CMB Meeting Minutes #165

REFERENCE Project No. M544.1, Contract No. 149 Task 1-8.02

SUBJECT: Configuration Management Board Meeting # 165 – Rev. No. 0

Project No. M544.1, Contract No. CS-149
Program/Construction Management
Configuration Management Board (CMB) Meeting No. 165
April 09, 2014
3:00pm – 5:00pm
Central Subway Project Office
821 Howard St. 2nd Floor
Main Conference Room

\\S:\p\003\1\544.1\FinalDesign\DRAWINGS\CS155-2\1255\SHEET FILES\03_STRUCTURAL\02_EXCAVATION AND GROUND SUPPORT\12550302ES100_R1.dwg
 ksmrth Thu Jan 10 2013 3:15 pm ES-100

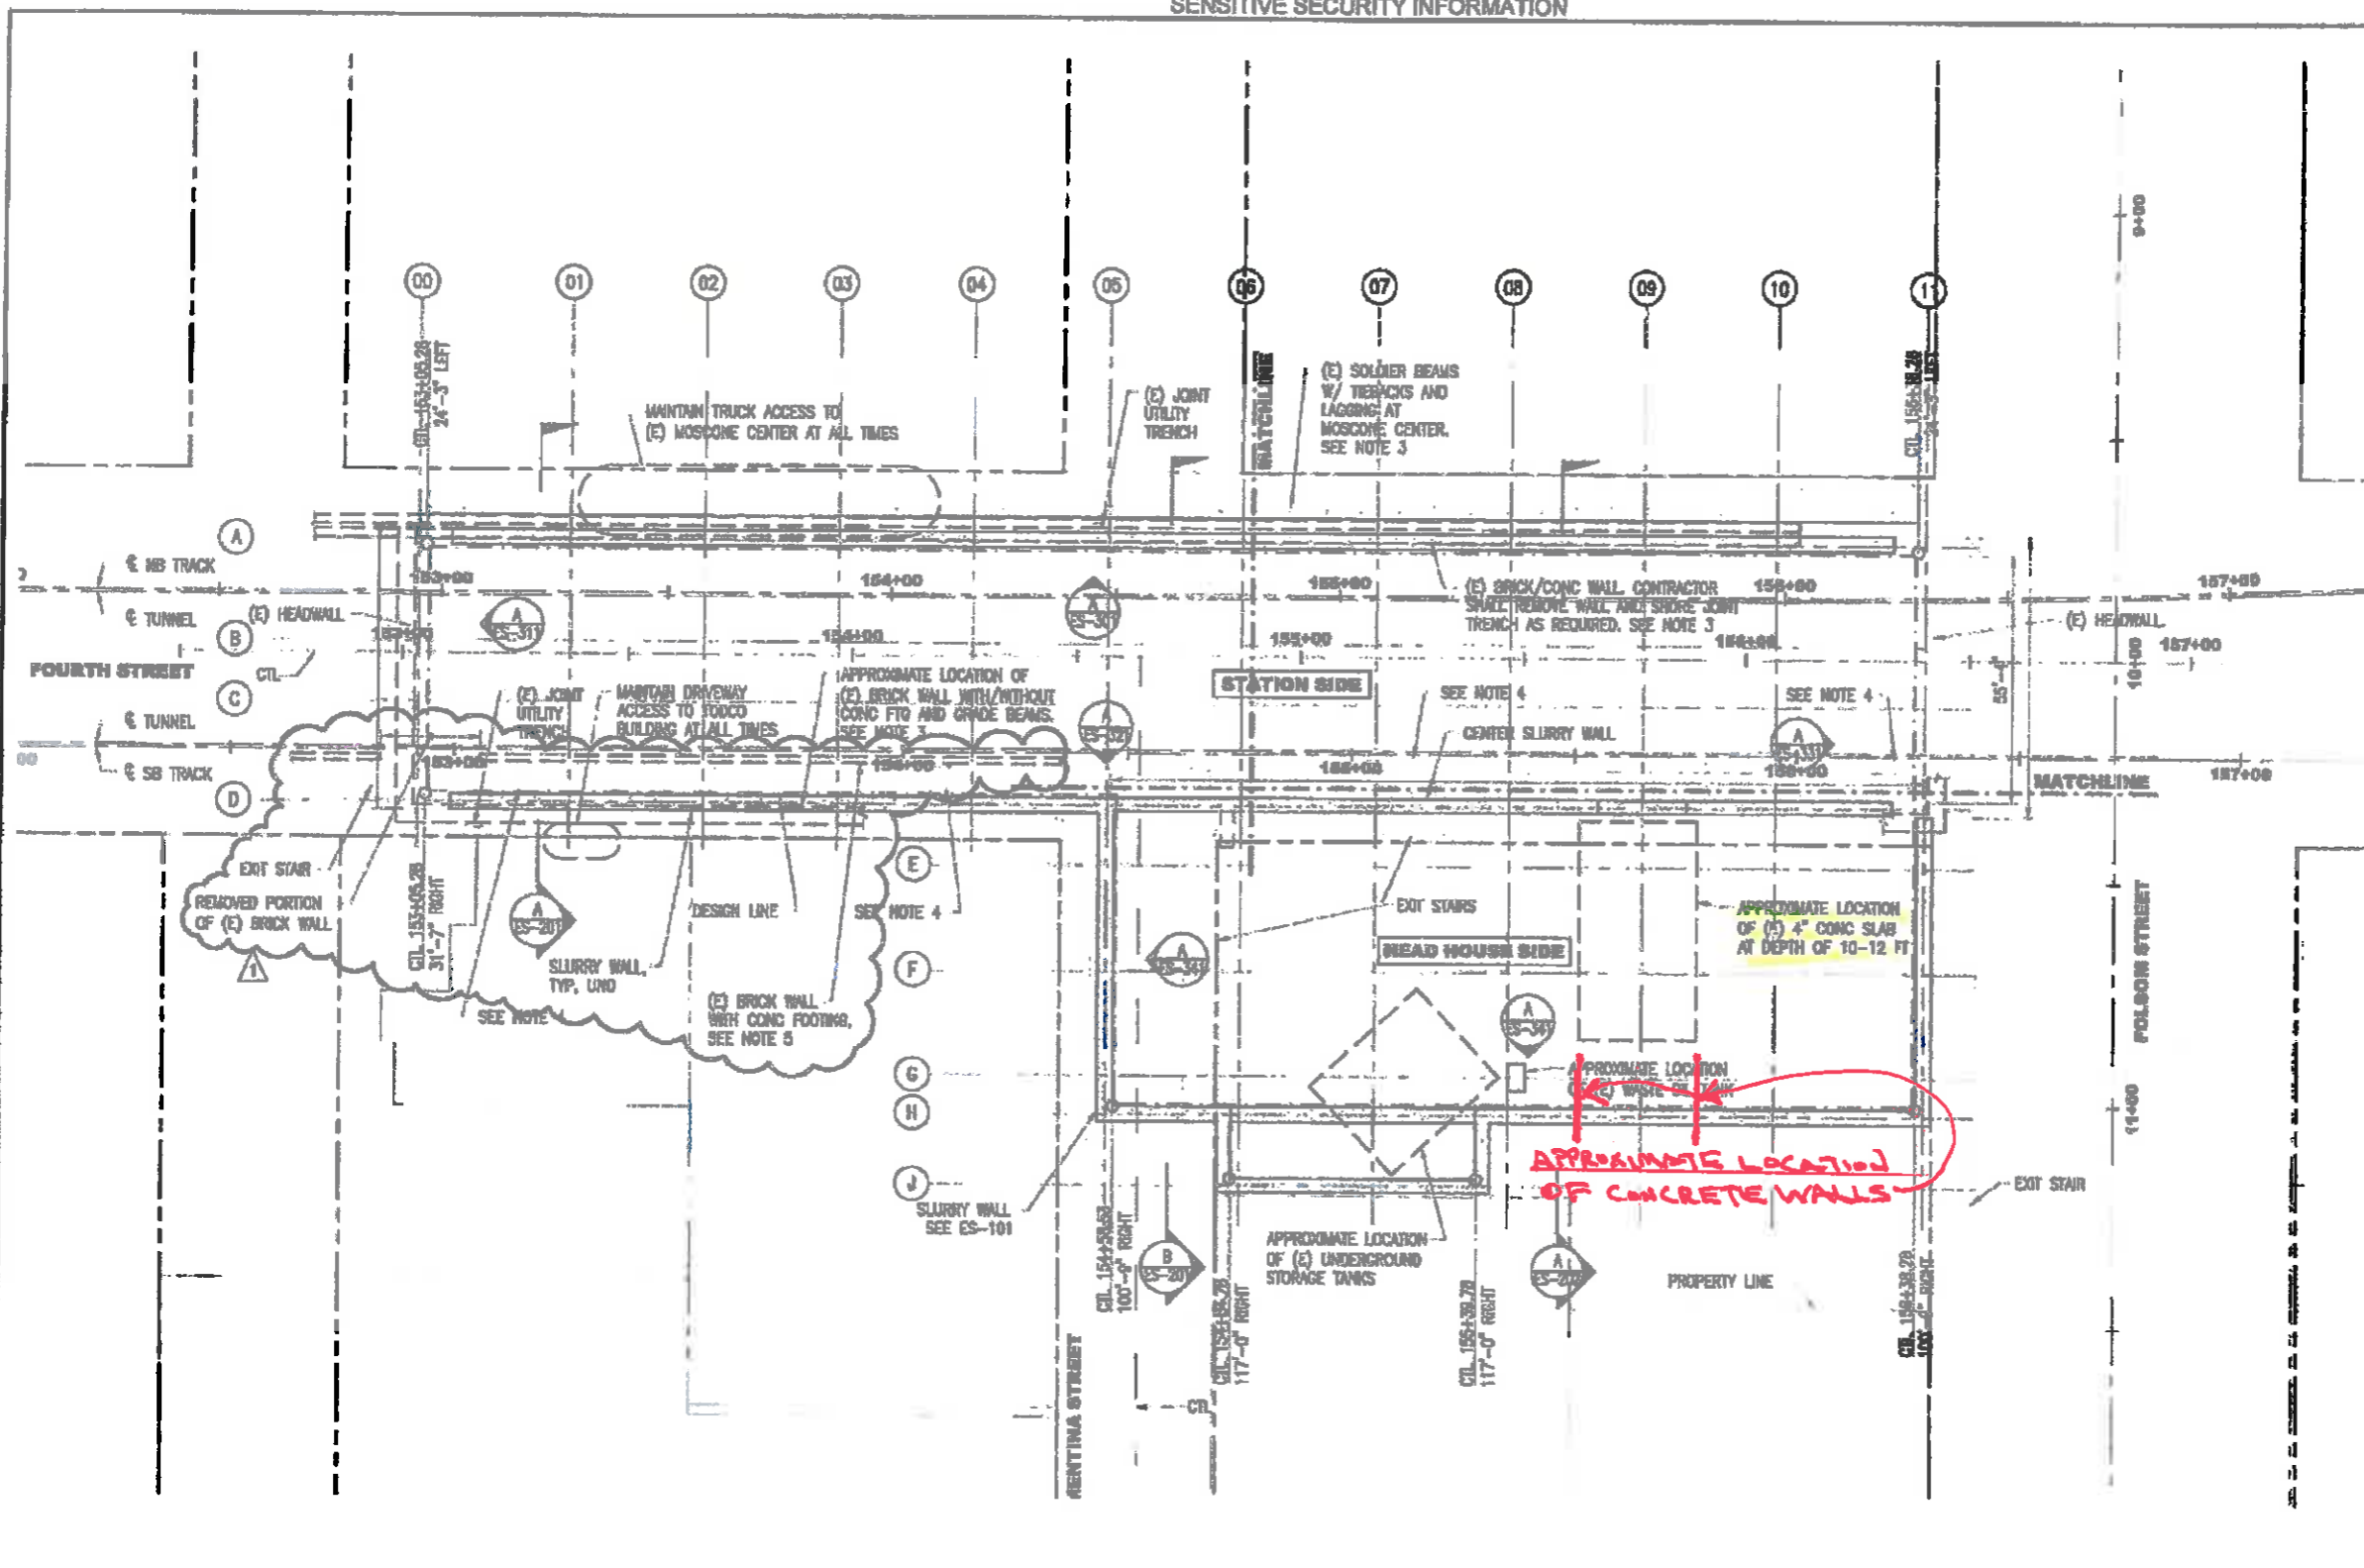
5. LOCATION OF OBSTRUCTION _____
6. METHOD USED TO OVERCOME OBSTRUCTION
Excavator-mounted breaker would be needed to remove the buried concrete walls interfering with guidewalls (similar to FACO #12 – YBM Buried Concrete Wall).

4-	M. Vilcheck presented CN1300 Notice of Different Site Condition - Buried Concrete Wall at YBM. During potholing work the Contractor encountered buried concrete wall about 10' below grade at Folsom on west side of 4th Street. The RE requested approval to authorize. The CMB agreed with the evaluation of DSC and provided authorization not to exceed \$15K tracked on force account.	
5-	M. Vilcheck presented CN1300 Notice of Different Site Condition - Abandoned Sewer Line on 4th Street. During excavation the Contractor hit an abandoned 3x5 brick sewer, which was shown on the contract drawing as being slurry filled but was discovered not to have been filled. The RE requested approval to authorize the Contractor to install temporary plugs in the sewer line and backfill the excavation with sack slurry. The CMB agreed with the direction, authorizing the work to be performed on force account with a not to exceed amount of \$10K .
